# DEVELOPMENT REVIEW BOARD REPORT

CASE NUMBER/ PROJECT NAME	<b>89-DR-2004#3</b> <b>Perimeter Center Parkview Bldgs 3 &amp; 4</b>		
LOCATION	8333 & 8355 E. Hartford Drive		
REQUEST	Request approval of two (2) office buildings (Buildings 3 & 4) on Lot 6 of the Perimeter Center.		
OWNER	Jon Coulter 480-563-5247	ENGINEER	WRG Design 602-977-8000
ARCHITECT/ DESIGNER	Butler Design Group / Rick Butler 602-957-1800	APPLICANT/ COORDINATOR	Land Development Services LLC 480-946-5020
BACKGROUND	<p><b>Zoning.</b></p> <p>The site is zoned Industrial Park (I-1 PCD) District which allows for office, medical offices, manufacturing, storage, warehouse and related uses. The Perimeter Center PCD (Planned Community Development) District provides overall planning and design standards for the 240-acre business park, including, circulation, drainage, open space and development design policies for the area.</p> <p><b>Context.</b></p> <p>The 10-acre site is located in Perimeter Center, north of Bell Road and east of N. 82<sup>nd</sup> Street. The site is currently under construction with office Buildings 1 and 2, which were approved by the Development Review Board in 2004 and 2005 respectively (Cases 89-DR-

SITE PLAN  
SCOTTSDALE, AZ  
5103  
FEBRUARY 10, 2006

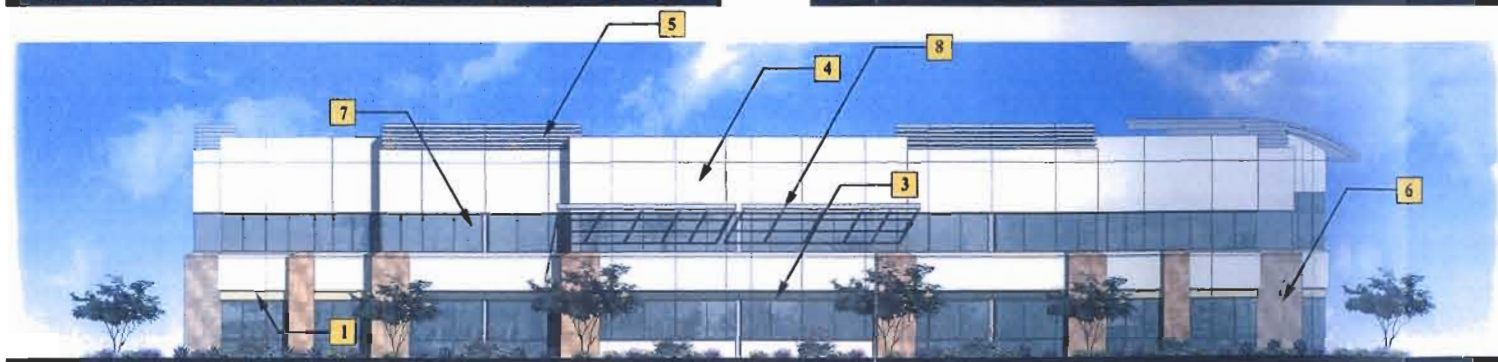
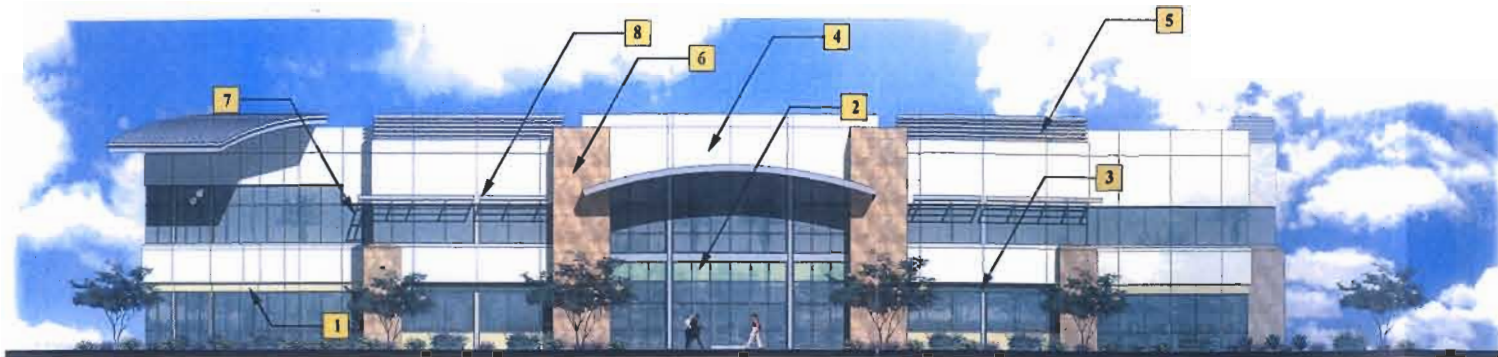
The configuration of the drive aisles within the parking lot should be slightly revised between Building 4 and the future Building 5 in order to reduce conflict of the three drives entering onto the main drive. It has been stipulated that the applicant continue working with Staff to resolve this issue.

9. *The configuration of the parking lot shall be revised between building IV and the future lot in order to reduce conflict of the 3 drives entering onto the main drive to the satisfaction of the Transportation and Development Services Staff. Provide documentation of approval at time of final plans submittal.*

# DEAD-END PARKING AISLE DETAIL

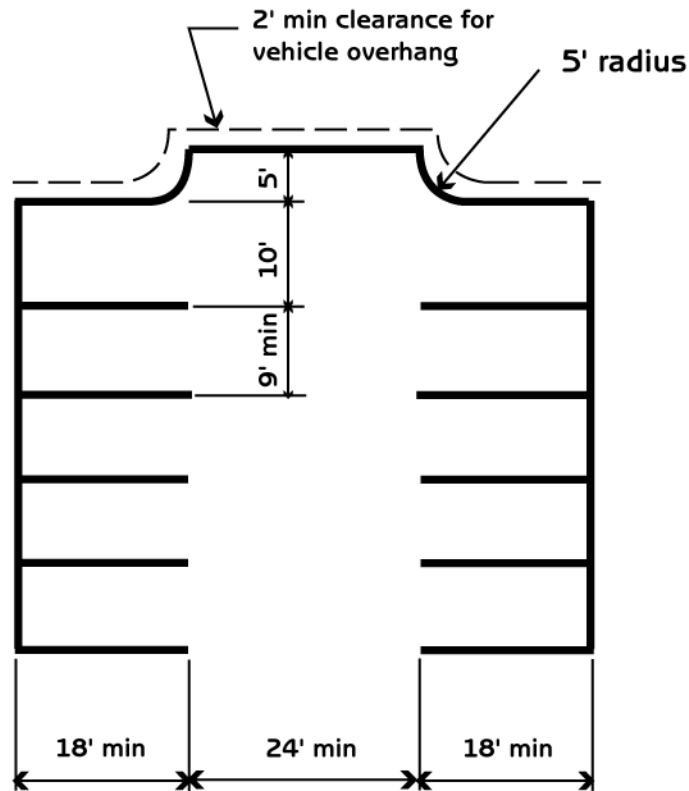
32. Provide a pedestrian connection from existing sidewalk on Hartford Drive to northeast corner of the site connecting the north portion of the building.
33. The main drive aisle, south or the proposed east building shall be modified to eliminate crossover movements and to provide access to the proposed refuse enclosure per City of Scottsdale refuse access requirements. The revised plan is subjected to review and approval by City of Scottsdale Transportation Engineering staff.
34. The developer shall provide a minimum parking-aisle width of 24 feet.
35. The developer shall provide internal circulation that accommodates emergency and service vehicles with an outside turning radius of 45 feet and inside turning radius of 25 feet.
36. The developer shall design the dead-end parking aisle in general conformance with the included detail.

## NOTES:

1. Maximum dead-end parking aisle length is 150 feet.
2. If the length exceeds 150 feet, a turn-around shall be provided for emergency vehicles.
3. No refuse enclosures are permitted on a dead-end aisle.
